MEMORANDUM

To: Planning Board
From: Lauren A. Wasilauski, Open Space & Stewardship Director
Date: July 14, 2023
Re: PB-03-23: Harlingen Associates, LLC
Block 6001 Lots 33, 34, 34.01, 35, 35.01, 36 (Route 206)
Preliminary & Final Subdivision & Site Plan

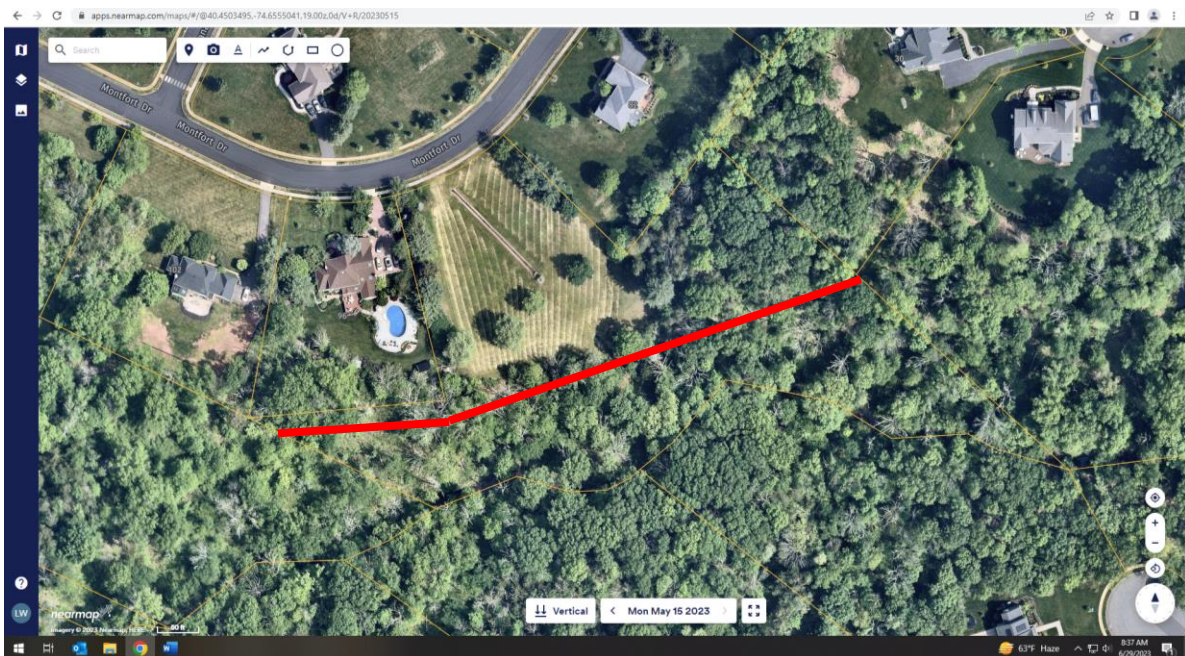
1. The Applicant proposes to develop the following:
 - a. Three (3), two-story apartment buildings, containing 18 residential units (total), comprised of 11 affordable units and 7 market rate units
 - b. Thirty six (36), three-bedroom townhouses with driveways and two car garages
 - c. Associated sidewalks, sitting areas, tot lot, bike storage, dog park, etc.
 - d. A retention basin (or wet pond) is proposed for stormwater management
 - i. The EIS states the pond has been designed in accordance with NJDEP's new Green Infrastructure Rule amendment.
2. Approximately 13.329 acres of the total site (22.189 acres) is proposed for development with 8.86 acres proposed to be dedicated to the Township, mostly

- containing wetland areas and stream corridor at the rear of the property (eastern portion).
3. The properties formerly contained single family residential uses and commercial uses which have been demolished.
 4. Access is proposed from US Route 206.
 5. The properties are located within the Site-Specific Inclusionary Zoning District (SSIZ-3).
 6. The proposed development will be served by public water from New Jersey American Water, and sewer from the Township's Pike Brook Wastewater Treatment Plant. A pump station is proposed for the southeast part of the site.

Red line represents approximate alignment of proposed force main. A significant amount of trees will be removed if the force main is located through the Township's basin. Nearmap May 15, 2023 image.

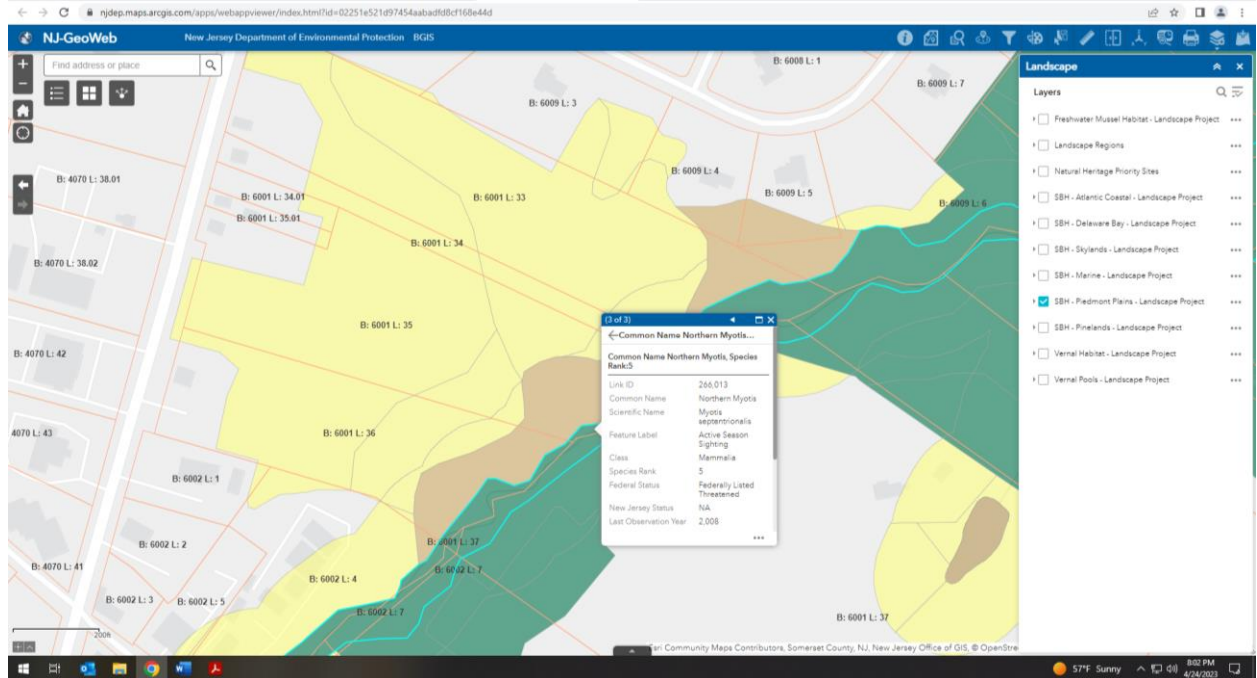
4. This office reviewed the project with the Open Space Committee and they are very concerned that the alignment impacts an existing conservation easement on the Township's property (6009/6) and will require significant tree removal. The Committee is also concerned about the precedent to be set by this decision – that

- a. This area was protected by a conservation easement at the time of a previous Planning Board approval and directed to be protected in its natural state due to the valuable resources present. Trenching through these areas to install a force main, and then continuing maintenance to keep the area clear of trees and brush to protect the integrity of the pipe will impact these areas and cause fragmentation of habitats for plant and animal communities and likely result in the proliferation of invasive species.
- b. When weighing the alternatives, the Board should consider whether the ability of 54 residences connecting to sewer is a significant enough benefit to warrant effectively nullifying a conservation easement, cutting dozens of trees, and creating permanent disturbance to habitat.

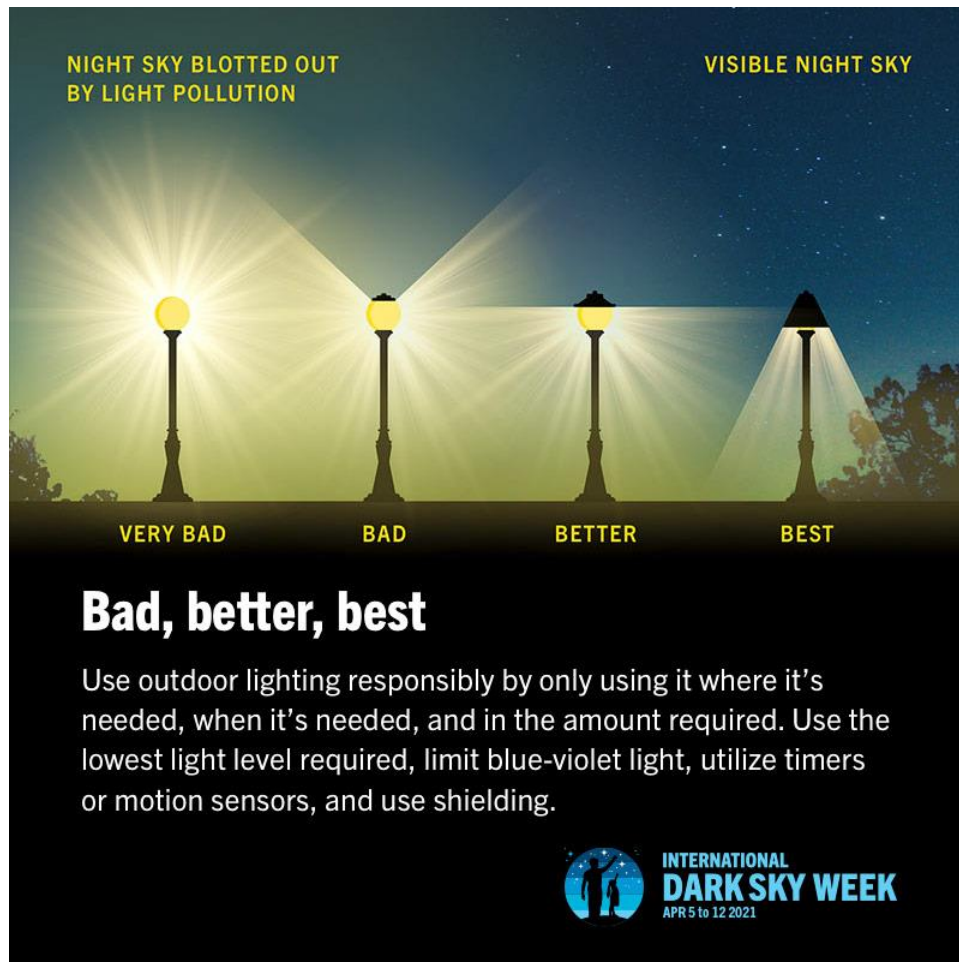
1. On sheet 12, a property entrance sign and apartment entrance sign are shown with details for lighting.
 - a. Since the time of the Site Plan Subdivision Committee, the Applicant has revised the plans to incorporate lighting that is directed downward. The notes also indicate that shields will be added and the color temperature will be no greater than 3000K. These notes are acceptable to this office, and we appreciate the revisions made.
2. The lighting along the streets and around the site shown have also been revised to incorporate comments made at Site Plan Subdivision Committee. The street lighting

is now Lithonia D-series size 1. The note on sheet 31 reads that external glare shield (EGSR) will be installed on all fixtures. This change is welcome.

3. The Applicant should select the lighting option that utilizes a color temperature no greater than 3000 kelvins.
4. This office recommends these specifications about shields and color temperature be included as conditions imposed by the Board should the proposal be approved.
